# UNITED STATES PATENT AND TRADEMARK OFFICE

APPLICATION NO.	FILING DATE	FIRST NAMED INVENTOR	ATTORNEY DOCKET NO.	CONFIRMATION NO.
10/070,467	07/11/2002	Martin John Charles Offa-Jones	THOM-0020	4678

## Office Action Summary

## DETAILED ACTION

FIG. 1

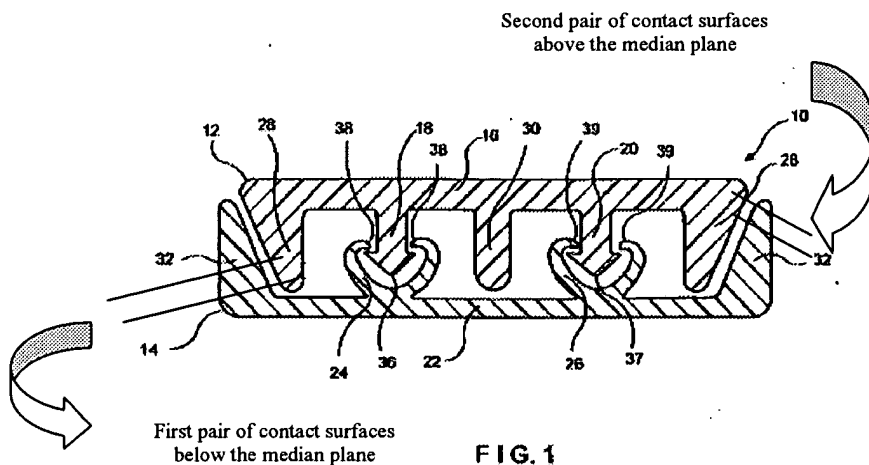
Malin (figure 1) teaches a reclosable fastener for bags, comprising a first element 12 comprising a first elongate body portion 16, at least one first upstanding elongate profiled member 18, 20 extending away from the first body portion, a first upstanding post comprising a wedge-shaped member 28 at a first lateral margin of the first body portion, and a first heel comprising an identically configured wedge-shaped member 28 at a second lateral margin of the first body portion; a second element 14 comprising a second elongate body portion 22, at least one second upstanding elongate profiled member 24, 26 extending away from the second body portion, a second upstanding post comprising a wedge-shaped member 32 at a first lateral margin of the second body portion, and a second heel comprising an identically configured wedge-shaped member 32 at a second lateral margin of the second body portion; wherein the first and second profiled members are releasably engagable when the first and second elements are pressed together with the first and second profiled members facing each other in order to produce

an engaged condition of the first and second elements; and wherein, in the engaged condition, both the first post and the second heel, and the second post and the first heel, are aligned and are arranged to contact each other at respective complementarily angled contact surfaces thereof to form a configuration which provides resistance to compression forces exerted on the first and second elements in their engaged condition thereby substantially preventing distortion of the first and second profiled members under application of a load urging the first and second elements together when in their engaged condition (col. 4, lines 36-61). Pairs of contact surfaces can easily be chosen so as to lie to respective opposite sides of a median plane of separation lying between the first and second body portions, the contact surfaces being angled relative to the median plane and offset therefrom in respective opposite directions perpendicular thereto. There is nothing in the claim language precluding such a labeling.

Malin (figure 1) teaches a reclosable fastener for bags, comprising a first element 12 comprising a first elongate body portion 16, at least one first upstanding elongate profiled member 18, 20 extending away from the first body portion, a first upstanding post comprising a wedge-shaped member 28 at a first lateral margin of the first body portion, and a first heel comprising an identically configured wedge-shaped member 28 at a second lateral margin of the first body portion; a second element 14 comprising a second elongate body portion 22, at least one second upstanding elongate profiled member 24, 26 extending away from the second body portion, a second upstanding post comprising a wedge-shaped member 32 at a first lateral margin of the second body portion, and a second heel comprising an identically configured wedge-

Applicant's arguments filed December 9, 2004 have been fully considered but they are not persuasive. Applicant argues that with respect to figure 1 of Malin that

In fact, with reference to the individual embodiments of the Malin patent, in Figure 1, the angled contact surfaces of the marginal high compression members 28 and 32 of the respective fastener parts lie to both sides of the median plane and are not offset therefrom.

There is no doubt that the angled contact surfaces of the marginal high compression members 28 and 32 of the respective fastener parts lie to both sides of the median plane, but there is nothing in the claim construction that prohibits this because portions of the angled contact surfaces are clearly offset to opposite sides of the median plane. Applicant has chosen to utilize the open-ended language “comprising” and this language fails to prohibit added structure such as that shown by Malin.

Applicant further argues that “post” and “heel” are structurally distinct from each other. However, these terms are broad and there are no features or dimensions claimed that would distinguish one from the other. The angled surface toward the end of a post contacts an angled surface adjacent the opposite base considered to be a heel. While obviously, there are features and dimensions disclosed that distinguish a “post” from a “heel”, limitations from the specification are not read into the claims. See *In re Van Geuns*, 988 F.2d 1181, 26 USPQ2d 1057 (Fed. Cir. 1993).
